### KNOXVILLE/KNOX COUNTY METROPOLITAN PLANNING COMMISSION SUBDIVISION REPORT - CONCEPT

► FILE #: 5-SC-07-C		AGENDA ITEM #:	12		
POSTPONEMENT(S):	5/10/2007	AGENDA DATE:	6/14/2007		
SUBDIVISION:	LOYSTON ROAD SUBDIVISION				
APPLICANT/DEVELOPER:	MELL MASHBURN				
OWNER(S):	Mell Mashburn				
TAX IDENTIFICATION:	3 79				
JURISDICTION:	County Commission District 8				
► LOCATION:	South and north side Loyston Rd., west of	of Maynardville Pike.			
SECTOR PLAN:	North County				
GROWTH POLICY PLAN:	Rural Area				
APPROXIMATE ACREAGE:	59.6 acres				
ZONING:	A (Agricultural)				
EXISTING LAND USE:	Vacant land				
PROPOSED USE:	Detached residential subdivision				
SURROUNDING LAND USE AND ZONING:	North: Residences and vacant land / A (Agricultural) South: Residences / A (Agricultural) East: Residence and vacant land / A (Agricultural) West: Residence and vacant land / A (Agricultural)				
NUMBER OF LOTS:	33				
SURVEYOR/ENGINEER:	Robert G. Campbell and Associates				
ACCESSIBILITY:	Access is via Loyston Rd., a minor collector within a 40' right-of-way, and Old Maynardvi portion of the road fronting this property has with a 40' right-of-way.	lle Pike, a local street	(the

5-SC-07-C

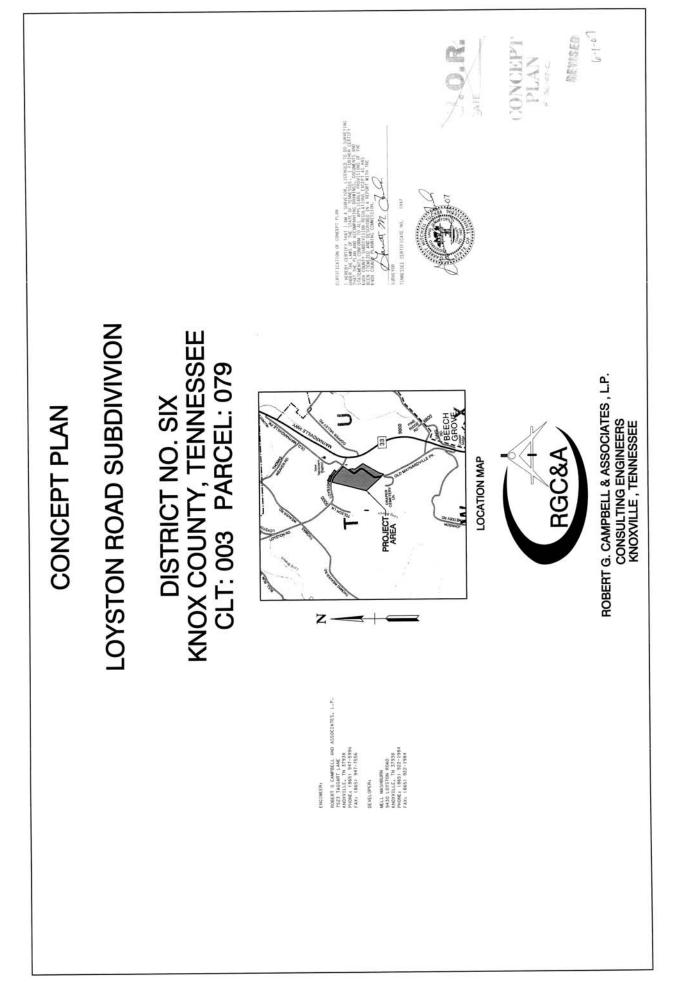
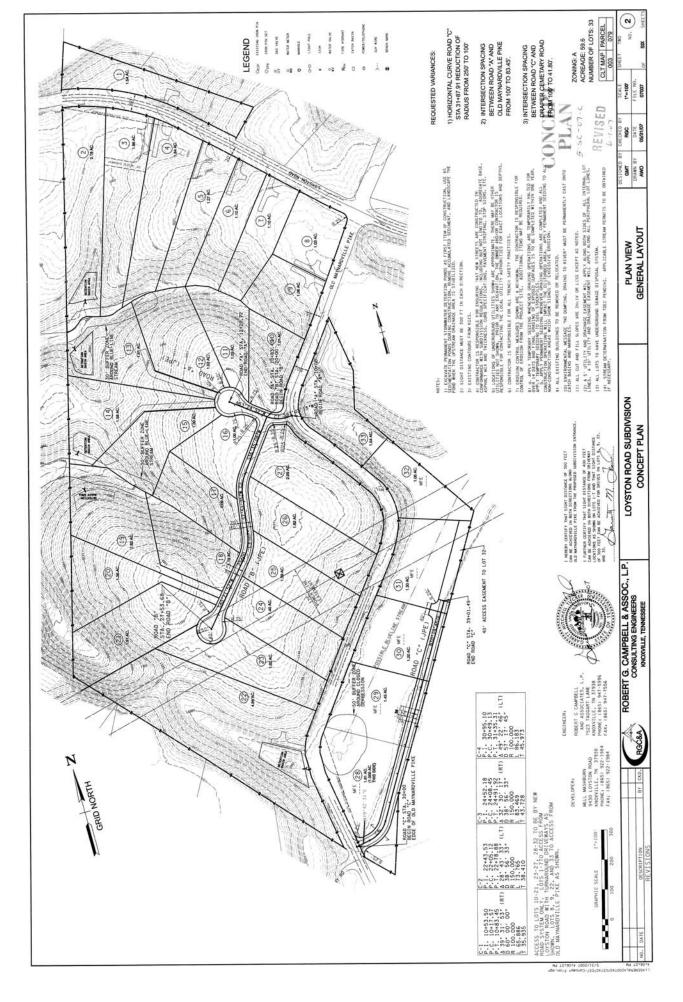
3. Placing a note on the final plat that all structures will have to be located at least 50' from the top of the sinkhole/closed contour area identified on the plat in the area of Lots 28 and 29. Construction within the 50' setback may be permitted if a geotechnical study prepared by a registered engineer states that building within

If it is determined by TDEC that the drainage feature across Lots 28-32 is designated as waters of the State, a 30' buffer shall be shown on the final plat along the creek (15' on either side of the center of the creek).
 Placing a note on the concept plan that all intersection grades have been approved by the Knox County Department of Engineering and Public Works.

7. Stormwater detention areas need to be located on more than one lot or identified as common area (Lots 2, 13 & 22).

8. Placing a note on the final plat that Lots 10-21 and 23-32 shall have access from the Joint Permanent Easement (JPE) street system only. Lots 1-9, 22 and 23 shall have direct access to the public street system subject to providing turnaround driveways and each driveway having adequate sight distance.

10. Revising the concept plan to show the JPE extending to Lot 32 (not as a separate 40' easement) and moving the turnaround to the end of the JPE.

11. Placing a note on the concept plan and final plat that the portion of Lot 28 that is located on the southeast side of the JPE is not a building lot.

13. Identifying the Minimum Floor Elevation (MFE) on the final plat for Lots 28-32.
